L73X-A.03.17

To: Official After Sales Network  
Subject: Pipe insulation update.  
Date: May 19, 2017  
Pages 7

Pipe insulation update.

Aventador Coupè and Roadster.

**Removing/Installing tube 470103221B (LH side of the engine compartment)**

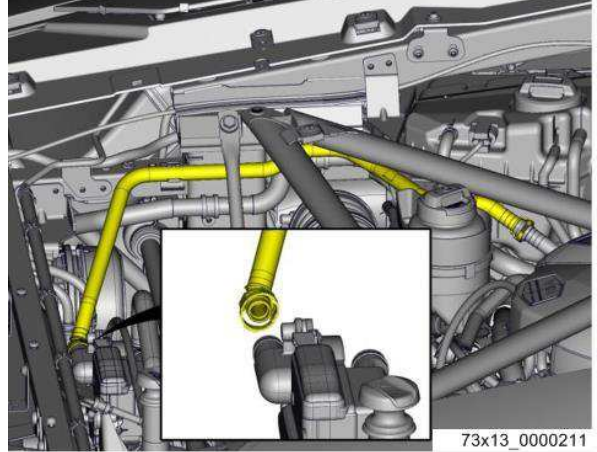
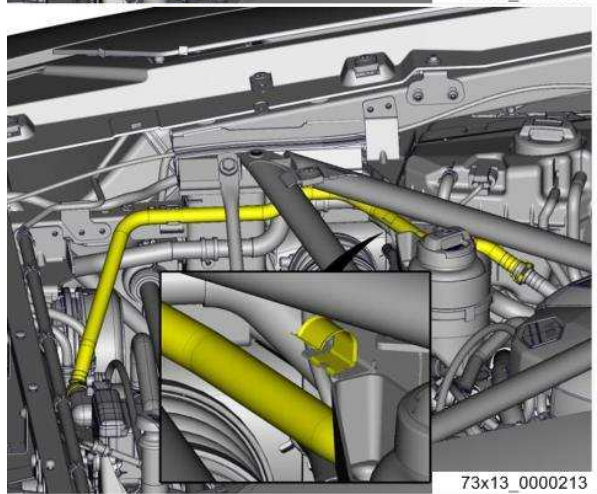
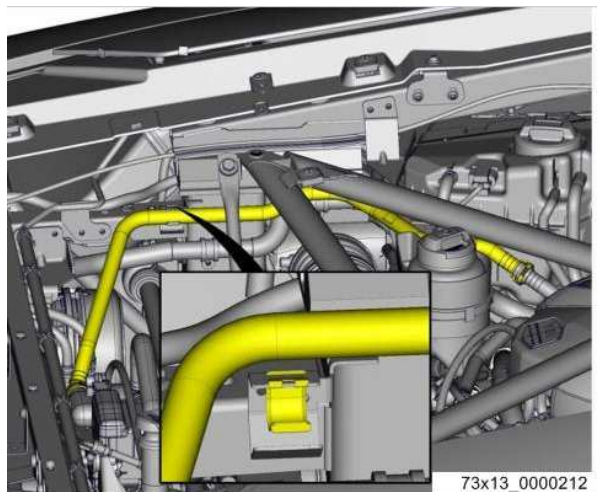
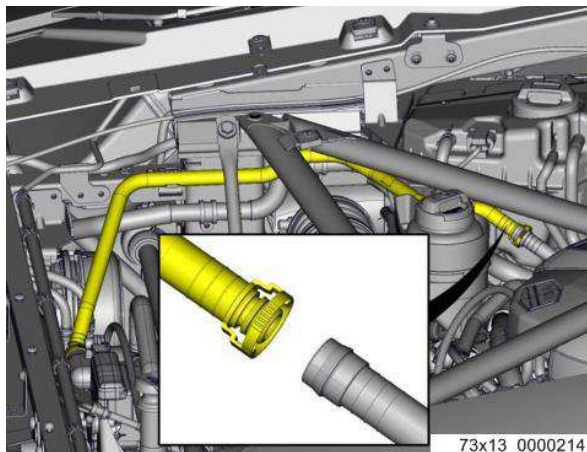
As a result of continuous product monitoring, Automobili Lamborghini Spa found some cars in which the insulation for blow by pipes are noncompliant with our quality esthetical standards, therefore has decided to introduce new designed pipes and thermal sheath.

The instruction herein detailed describes the replacement of the insulation and the blow-by pipes

11. Install the new tube (p/n 470103221C) by retracing steps 9 to 8 in order.
